Draft DSM Regulations 4th Amendments, 2018

TATA Power Trading Company Limited

21st Aug 2018

Clause 7(10): Change in sign of deviation

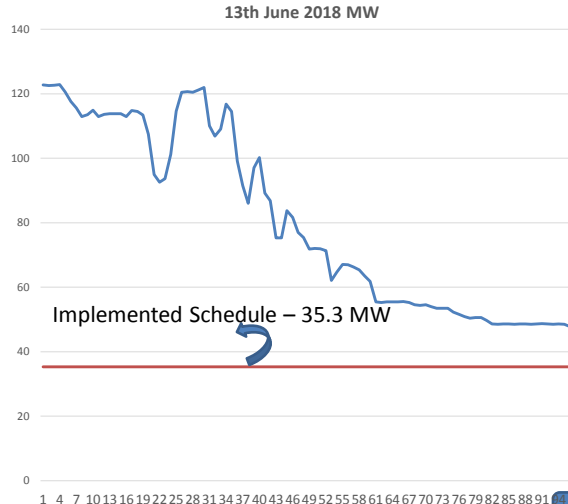
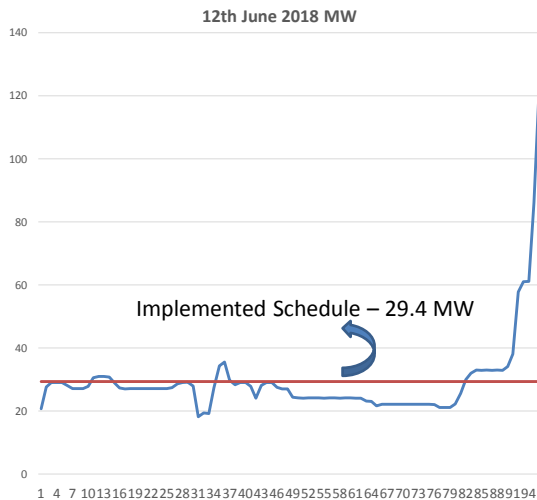
1. In absence of the provision of revising the schedule for Hydro Power Plants under STOA, the proposed amendments of change in sign of the deviation, would not be fair to generations which do not have pondage and generation is dependent on rain fall.
2. In case of Wind and Solar generators, intraday revisions should be allowed in STOA.
3. While generations from Thermal power plants are capable of matching the schedule during the day.
4. Hence, impact of deviation in the case of Wind, Solar and RoR plant are very high in STOA i.e. on Bilateral & Exchange platforms.

It is therefore requested that proposed amendment regarding additional charges of 20% on the daily base DSM in the event of sustained deviation in one direction should not be made applicable for Hydro projects especially RoR projects in India and such projects in neighboring countries
